# Intel<sup>®</sup> 80312 I/O Companion Chip

*Specification Update*

*November 2001*

Order Number: **273416-006**

**2. Figure 5-3 on page 5-7 has missing text**

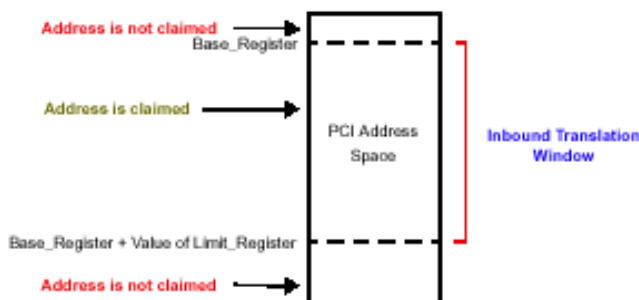
**Problem:** The figure shows 'se\_Register + Value...'. It should be 'Base\_Register + Value...'.

**Workaround:** Replace Figure 5-3 with the following:

**Figure 3-17. ECC Read Data Flow**

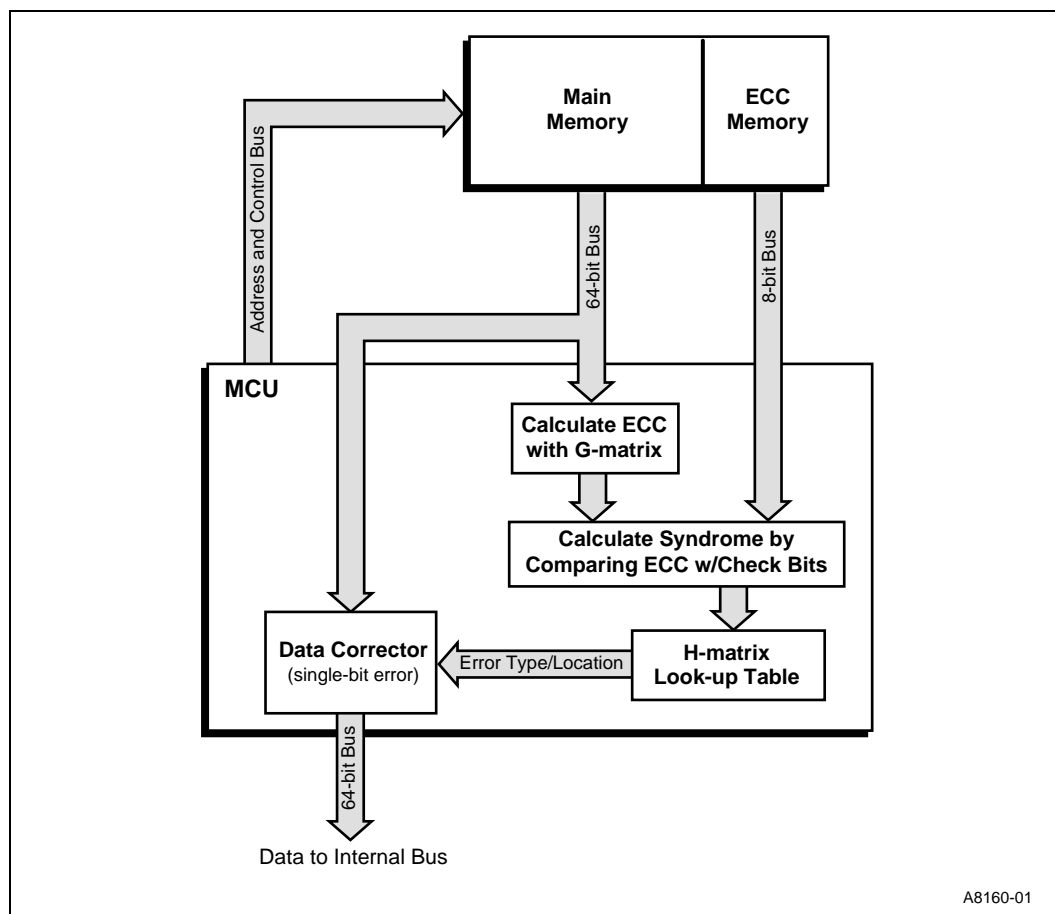
**Problem:** Syndrome Decoding Error Types and Symptoms are incorrectly stated.

**Workaround:** Replace Table 3-13 with the following and, add the adjacent paragraph with “new” Figure 3-17:

Figure 3-17 shows how the data flows through the ECC hardware for a read transaction.
